DART SERVICE INSTRUCTION

TO AMEND INSTALLATION INSTRUCTIONS IIN-D412-769 REV. C AND
INSTRUCTIONS FOR CONTINUED AIRWORTHINESS ICA-D412-769 REV. 1

REF. TCCA STC: SH08-38
REF. FAA STC: SR02682NY
REF. EASA STC: 10027063

Figure 1: Addition of D4679-1 Spacer
(D412-769-041 shown, D412-769-042 similar)

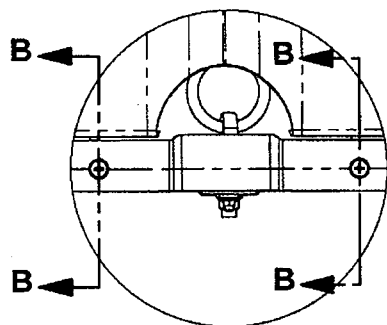
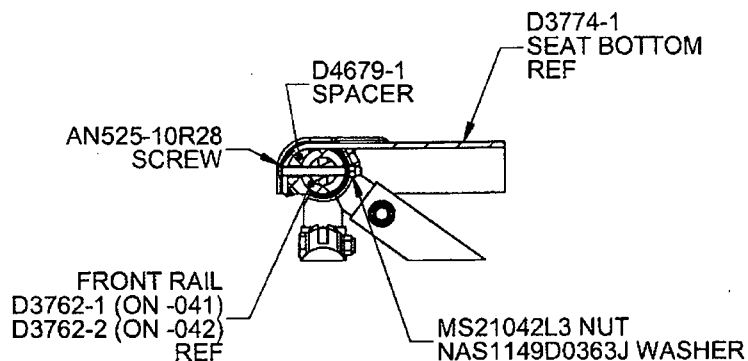
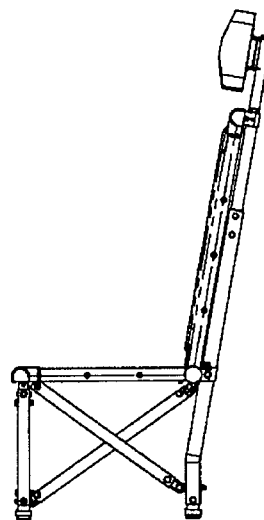
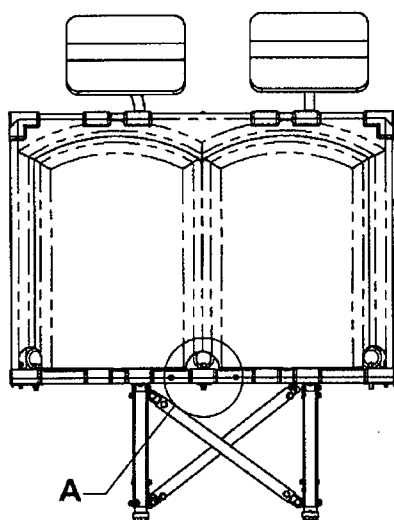
The purpose of this DSI (Dart Service Instruction) is to inform customers and operators that qty(2) D4679-1 Spacers were added to D412-769-011 Aft Facing Seat Kit and D412-769-041/-042 Aft Facing Seat, LH/RH at CHG 002 or later. This change also affects the hardware as shown in Figure 1 of this service instruction.

For replacement parts for D412-769-011/-041/-042 at CHG 002 or later, the parts list of ICA-D412-769 is updated as follows:

Qty -011	Qty -041	Qty -042	Part Number	Description
X			D412-769-011	AFT FACING SEAT KIT
1	X		D412-769-041	AFT FACING SEAT, LH
1		X	D412-769-042	AFT FACING SEAT, RH
	1		D412-769-043	AFT FACING SEAT ASSEMBLY, LH
		1	D412-769-044	AFT FACING SEAT ASSEMBLY, RH
	2	2	D4679-1	SPACER (ADD)
	11	11	AN525-10R22	SCREW (WAS QTY 13)
	2	2	AN525-10R28	SCREW (ADD)
	11	11	NAS1149D0332J	WASHER (WAS QTY 13)
	23	23	NAS1149D0363J	WASHER (WAS QTY 21)
